Y2K FIRMWARE UPGRADE KITS

FOR DANTEL MULTIPLE ALARM PROCESSORS EQUIPPED WITH 46600-36 FIRMWARE

This practice has been reissued to:

- Update the -38 firmware eeprom number from D82 to E82.

FIG. 2 - MAP EPROM LOCATION

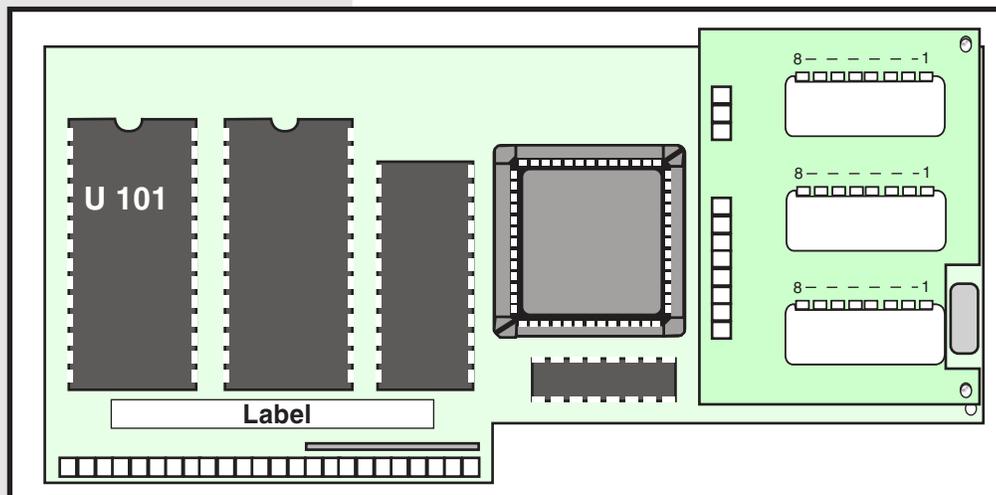
The programmed EPROM to change is U101, on the MAP's memory board. Refer to Fig. 2.

1. Remove the old EPROM from the socket in which it is installed.
2. The new EPROM is labeled E82-00289-00. Install the new EPROM in the socket, making sure that the notch on one end of the EPROM is on the same side as the notch in the socket. Also make sure that the pins on the EPROM do not bend as the EPROM is pushed into its socket.
